Access Compliance Report

Public Rights-of-Way

(Pedestrian Signals)

Intersection ID: N/A	Main Street:	Cross Street: N/A	Location: N/A
ADA ID: 56C6122F82C7	Signal Type: One Push Button-Non APS	Overall Compliance: No	Severity Score: BTN 1: N/A BTN 2: N/A No BTN: N/A
Codes/Mitigation Info/Possible Solution		Field Measurements/Component Compliance

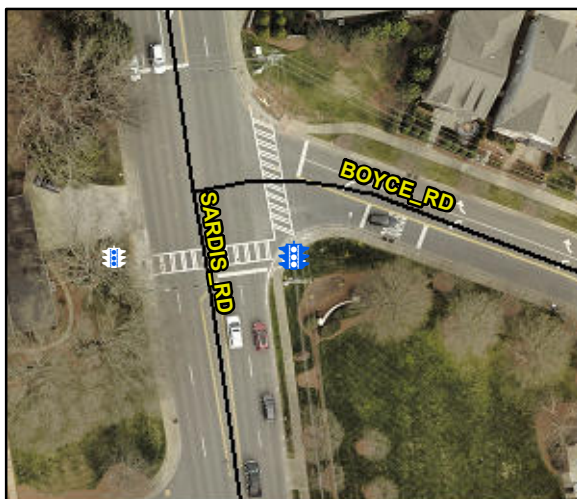
PROW/ADA: TMUTCD 4e.08, R404.2, R404.3

Yes	B 1 Clear Xing Direction?	ClearlyMarked	N/A	B 2 Clear Xing Direction?	N/A
	B 1 Crossing Direction	To SW		B 2 Crossing Direction	N/A
Yes	B 1 DistanceTo XWalk (in)	0.0	N/A	B 2 DistanceTo XWalk (in)	N/A
No	B 1 DistanceTo Curb (in)	74.0	N/A	B 2 DistanceTo Curb (in)	N/A
Yes	B 1 Diameter (in)	2.0	N/A	B 2 Diameter (in)	N/A

Possible Solutions: Replace Signal Push Button With APS Button on New Post. Remove & Relocate Sign.
